HOSHIZAKI AMERICA, INC.

SERVICE BULLETIN

SB07-0005R1

Subject: KM FLOAT SWITCH REDESIGN

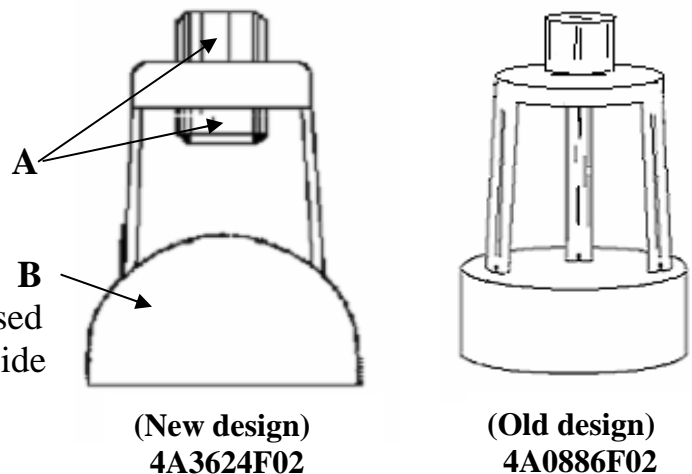
A recent design was made to the internal float of the float switch assembly. The current part number for the internal float (4A0886F02) was replaced by (4A3624F02). This new float is fully interchangeable and will sub when existing inventory is depleted. Current complete assembly part number (4A0886-01) now subs to (4A3624-01).

(A) Increased surface area:

Increased guide surface area and decreased guide inside diameter, will stop side to side movement preventing possible sticking during operation.

(A) New material and dome shape:

The new redesigned dome shape and change in material will reduce mineral build up by allowing water to “slide” off the top.
